LINE OF BUSINESS PORTABLE AUDIO

SERVICE NEWSLETTER

Published by:
Service Department Audio Systems

SERVICE NEWSLETTER

Portion of the Front board (copper side view)

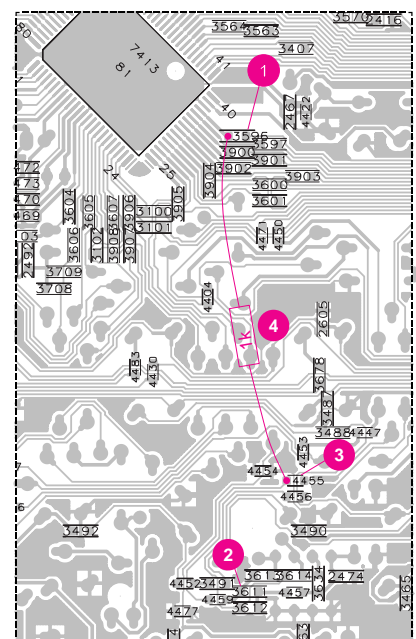
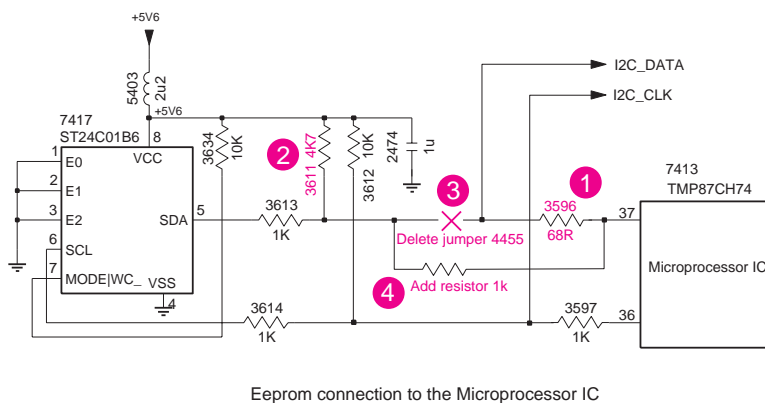
SYMPTOM : IRIS CODE M 1 7 0

- The set behaves strangely after switching it on via Standby button or mains supply re-connection. Strange behaviour includes:
- Loss of Tuner preset stations or tuning grid returns to 9kHz condition
 - When changing source to Tuner the set stalls for a few seconds and may or may not switch to Tuner mode
 - CD carousel rotates or the CD tray moves outwards
 - Tape deck motors start to run or relay starts activation and the deck starts engaging and disengaging
 - During this strange behaviour condition the set does not go into demo mode

CURE : The problem is caused by corrupted data being written into the EEPROM IC 7417 via the I2C_DATA line. The data corruption can be verified and cleared by performing an “EEPROM Format Test” in the Service Test Program.

The problem can be solved by the following hardware modification on the front board:

1. Ensure (change if necessary) that resistor 3596 is 68Ω (4822 117 12521)
2. Change resistor 3611 to 4.7kΩ (4822 051 20472)
3. Remove SMD jumper 4455
4. Add resistor 1kΩ (4822 050 11002) with insulated leads between pin 37 of microprocessor IC 7413 and junction of resistors 3611 and 3613 (left solder pad of jumper 4455)
5. Clear the corrupted data in the EEPROM as follows:
 - a) Enter the Service Test Program by holding the **PLAY ►** and **AUX** button depressed while switching on the mains supply
 - b) Perform an “EEPROM Format Test” by pressing the **SEARCH ◀◀** button to reset the EEPROM to default data
 - c) Exit the Service Test Program by disconnecting the mains supply

Portion of the Front board (copper side view)

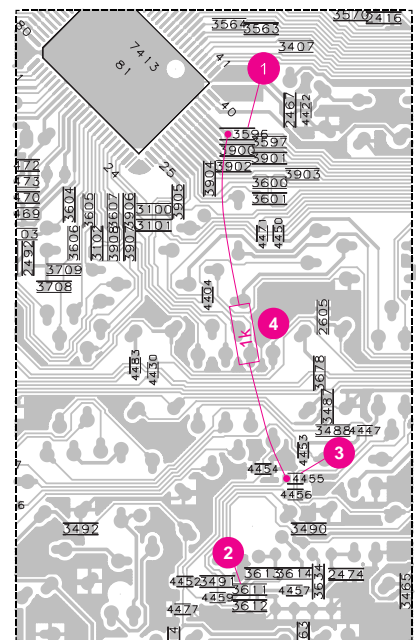
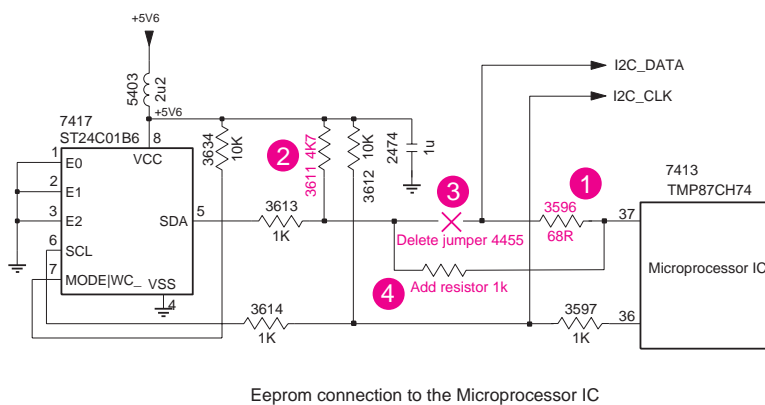
SYMPTOM : IRIS CODE M 1 7 0

- The set behaves strangely after switching it on via Standby button or mains supply re-connection. Strange behaviour includes:
- Loss of Tuner preset stations or tuning grid returns to 9kHz condition
 - When changing source to Tuner the set stalls for a few seconds and may or may not switch to Tuner mode
 - CD carousel rotates or the CD tray moves outwards
 - Tape deck motors start to run or relay starts activation and the deck starts engaging and disengaging
 - During this strange behaviour condition the set does not go into demo mode

CURE : The problem is caused by corrupted data being written into the EEPROM IC 7417 via the I2C_DATA line. The data corruption can be verified and cleared by performing an “EEPROM Format Test” in the Service Test Program.

The problem can be solved by the following hardware modification on the front board:

1. Ensure (change if necessary) that resistor 3596 is 68Ω (4822 117 12521)
2. Change resistor 3611 to 4.7kΩ (4822 051 20472)
3. Remove SMD jumper 4455
4. Add resistor 1kΩ (4822 050 11002) with insulated leads between pin 37 of microprocessor IC 7413 and junction of resistors 3611 and 3613 (left solder pad of jumper 4455)

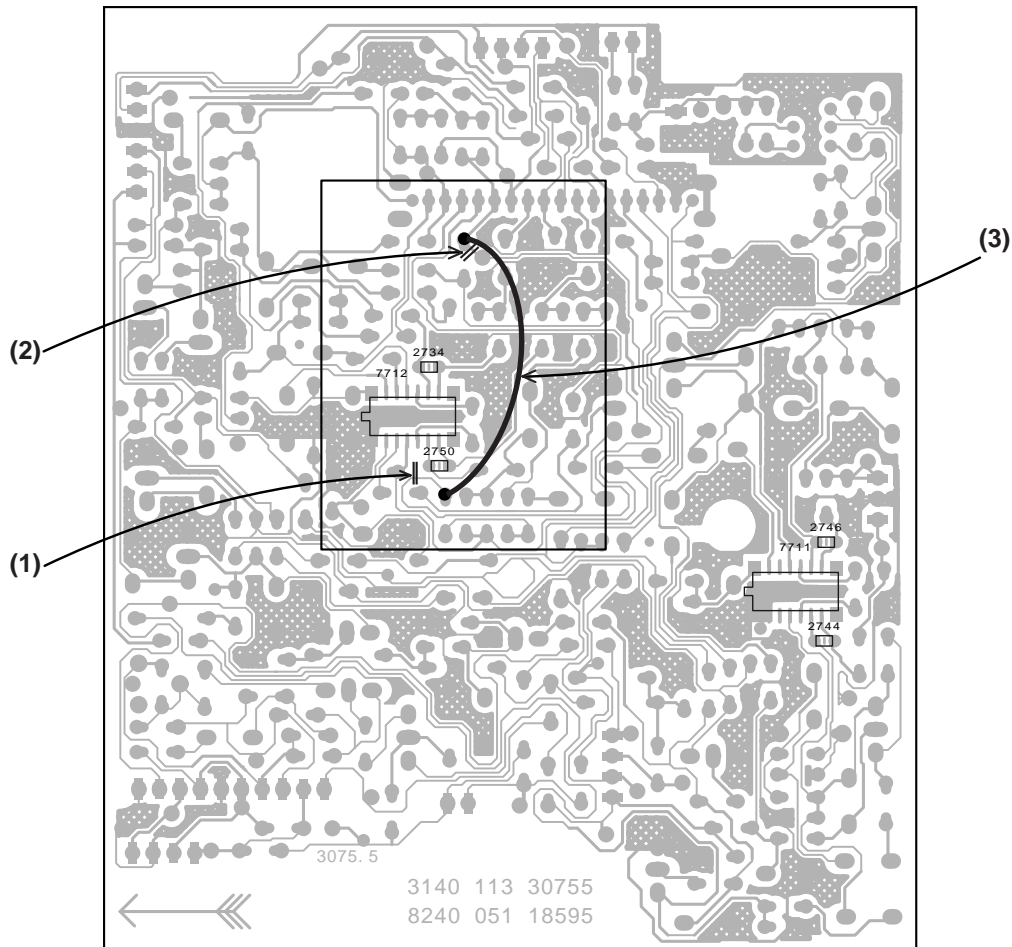
INFORMATION : On the rear cabinet, the ribs for holding the Battery Spring (item 459) are broken. In order to strengthen the ribs their wall thickness was increased and a radius was added.

REMARKS : Modification has been implemented in production from week 9934 onwards.

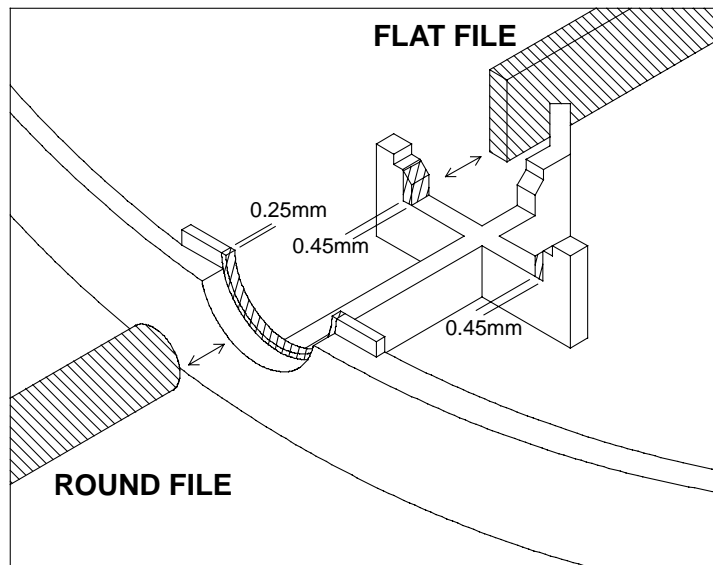
- SYMPTOM** : **IRIS CODE 6 1 1 X**
The Power ON/OFF switch 1496 or resistor 3594 is burst due to high transient current.
- CURE** : Additional to Service Newsletter PA99.02.11, on long term the layout of the Front board will be modified and following parts will be changed or added:
• Resistor 3456 changed to 15kΩ (4822 116 52244)
• Resistor 3457 changed to 5.6kΩ (4822 116 52289)
• Resistor 3516, 47Ω (4822 116 52195) added
• Diode 7483 and 7484, 1N4148 (4822 130 30621) added
- REMARKS** : Modification will be implemented in production from week 9932 onwards.
This information will be followed by Service Information A99-573 (3140 785 22023).

fig.1 – location of flex-foils

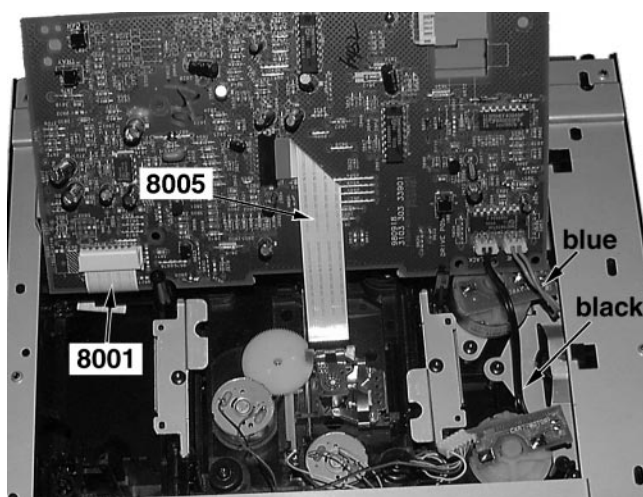
INFORMATION : Correction to the Service Manual, Partslist
The following flex-foils and flex-foil-connector were missing and have been added to the partlist of the 3CDC-99 Module (chapter 10).

pos.	code number	article description
1805	2422 025 09768	Flex-Foil-Connector 19P
8001	4822 320 12232	Flex-Foil 15P 480mm
8001	4822 320 12658	Flex-Foil 19P 480mm
8001	4822 320 12659	Flex-Foil 23P 480mm
8001	4822 320 12729	Flex-Foil 23P 400mm
8005	3103 308 91820	Flex-Foil 15P 95mm

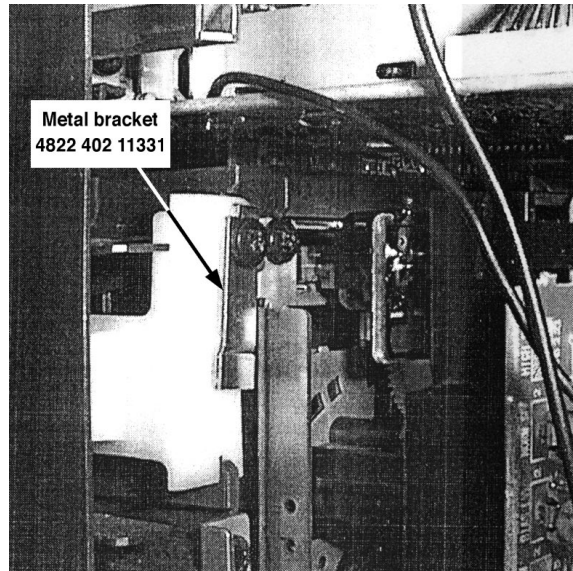
CURE : In addition to Newsletter issue AS98.09.03, the improved brackets (left & right) can be recognized by the modification shown below:

Sets with old brackets can be adapted by either

- i) adding a metal bracket (4822 402 11331) to press onto the back of the bracket left or right as shown below, or

- ii) replacing the old bracket by the modified one.

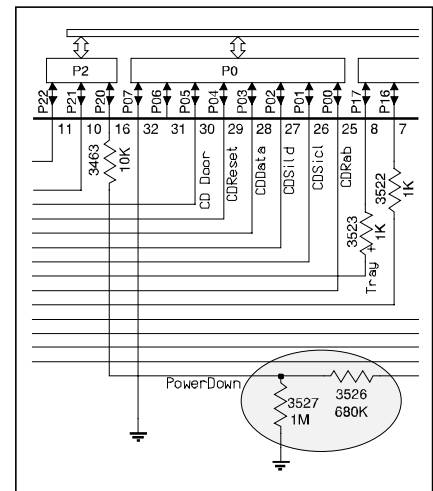
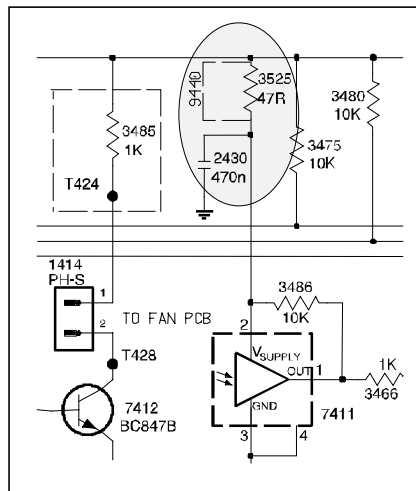
SYMPTOM : **IRIS CODE C 5 3 2**
 Sound is muted or distorted at start-up when playing a CD containing only two tracks.

CURE : The problem can be solved by adding a resistor of 100kΩ (4822 116 52234) across C445 on the CD board.

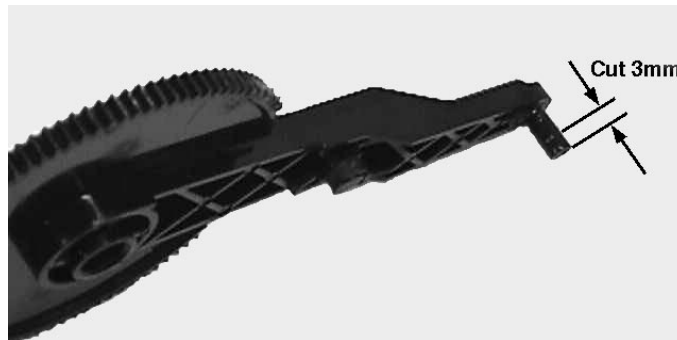
From production wk9835 onwards, the Tray and Crank have been modified. The groove on the tray is now deeper and likewise the pin on the Crank is 3mm longer.

Due to this change the new Crank does not fit into the old Tray anymore. But it is still possible to use the old Crank on the new Tray.

The new Tray can be recognized by its 10mm deep groove.

Because of limited stock of old Cranks, new Cranks have to be reworked for sets with an old Tray. This is done by cutting the pin by 3mm with a sharp NT-cutter (give it a clean cut & do not deform its circular cross-section) as shown below.

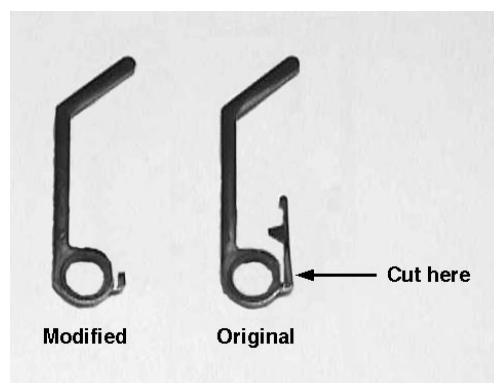
INFORMATION : **Replacement of CDM12.1 for 7-Disc Changer**
Production of CDM12.1 will stop. For service purpose CDM12.1 (4822 691 30278) will be replaced by service kit VAM1201 (4822 310 11263) when stock depletes.

For the above mentioned sets with 7-Disc Changer the new VAM1201 does not fit.

As an alternative, the CDM12.1 can be replaced by CDM12.1/T (4822 691 30343) without any further modifications.
